*** Note on Filler Neck and Cap**

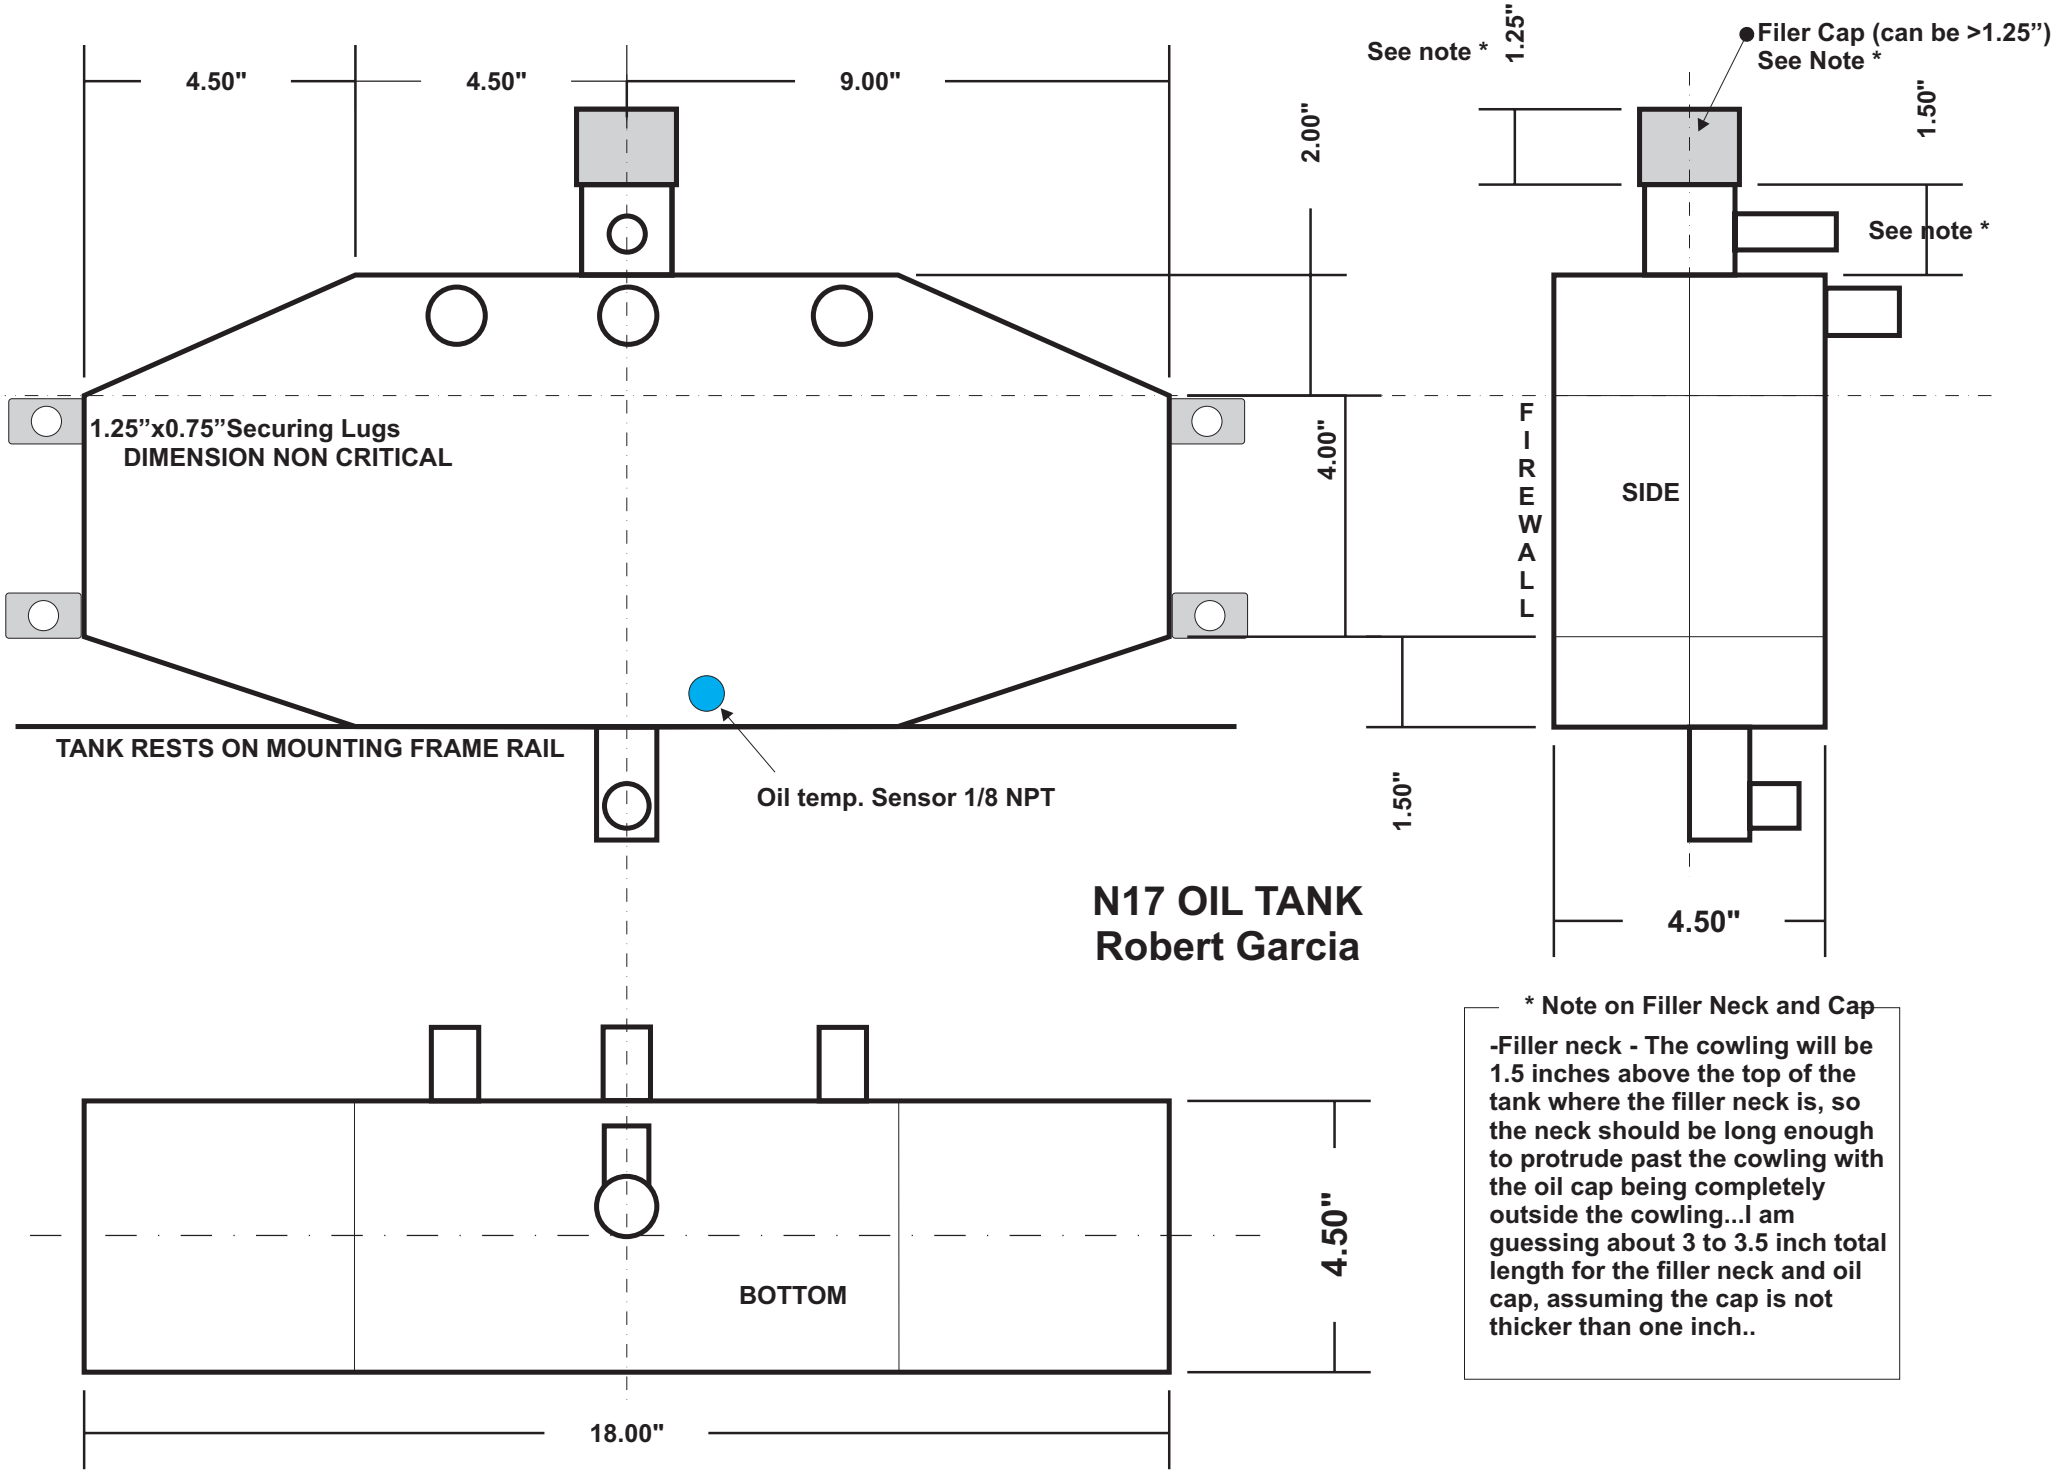
-Filler neck - The cowling will be 1.5 inches above the top of the tank where the filler neck is, so the neck should be long enough to protrude past the cowling with the oil cap being completely outside the cowling...I am guessing about 3 to 3.5 inch total length for the filler neck and oil cap, assuming the cap is not thicker than one inch..
